Documentation (Service Bulletin Completion action)

Reason and overview of the Service Bulletin (cause of problem if known)

This SB provides instructions on how to replace the oil thermostat.

Thermostat III (and previous thermostat versions, the replacement process is identical)

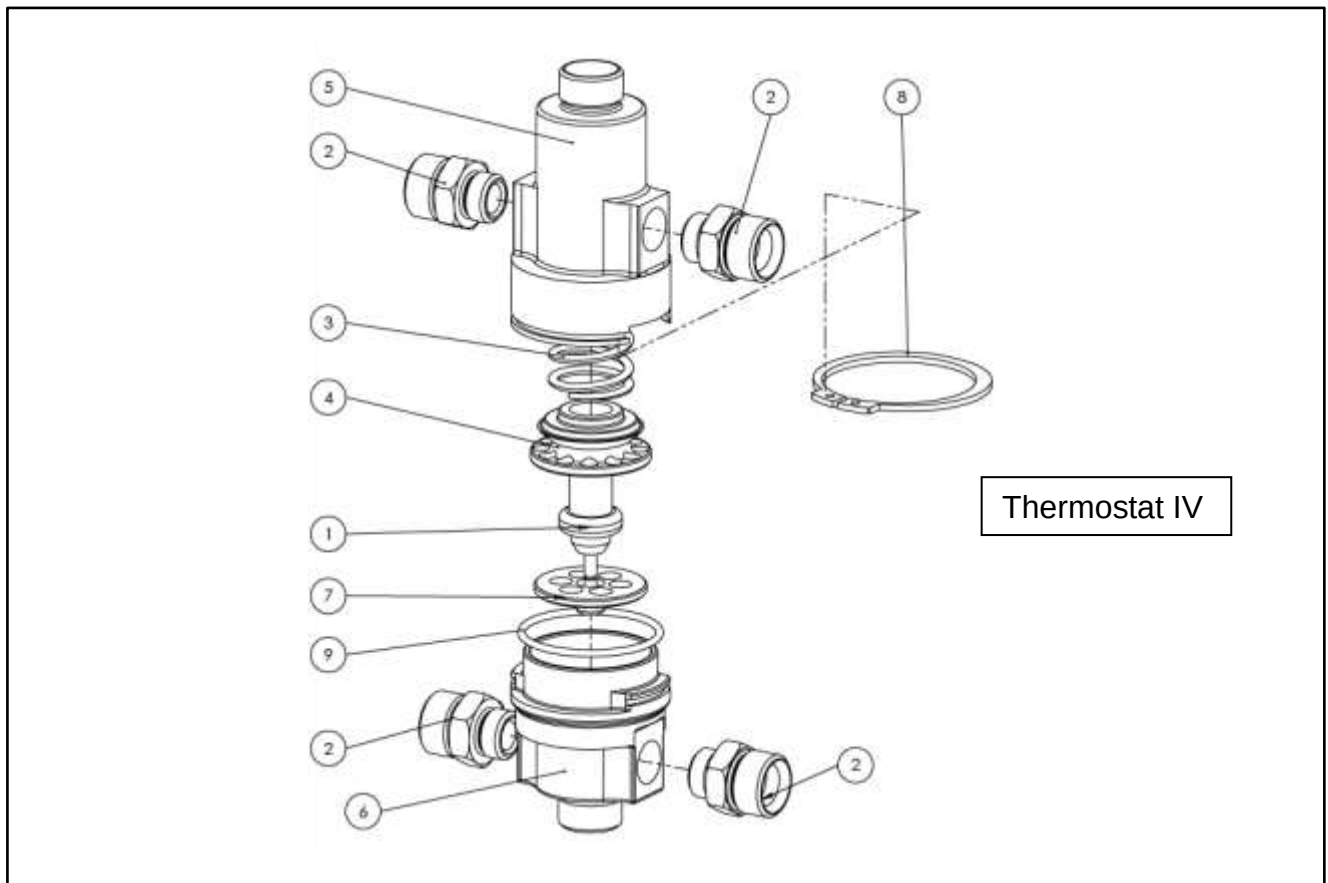
Through further research and lessons learnt in the market, predominantly in cold climate countries, AutoGyro has determined that a different oil thermostat (part no. 48159) calibrated to open at a higher oil temperature of 92°C provides improved oil temperature control.

5. Remove the screws (8) and nuts (9) securing the thermostat housing halves (1) & (3).
6. Separate the housing halves to gain access to the thermostat (4).
7. Remove the thermostat (4) and assemble the replacement item (48159).
8. Ensure the mating faces of the 2 thermostat housing halves are clean and degreased, and re-assemble with bolts (8) and new M5 SI nuts (9) (unless the remaining nylock prevailing torque is considered satisfactory by the engineer responsible) as per the original assembly.
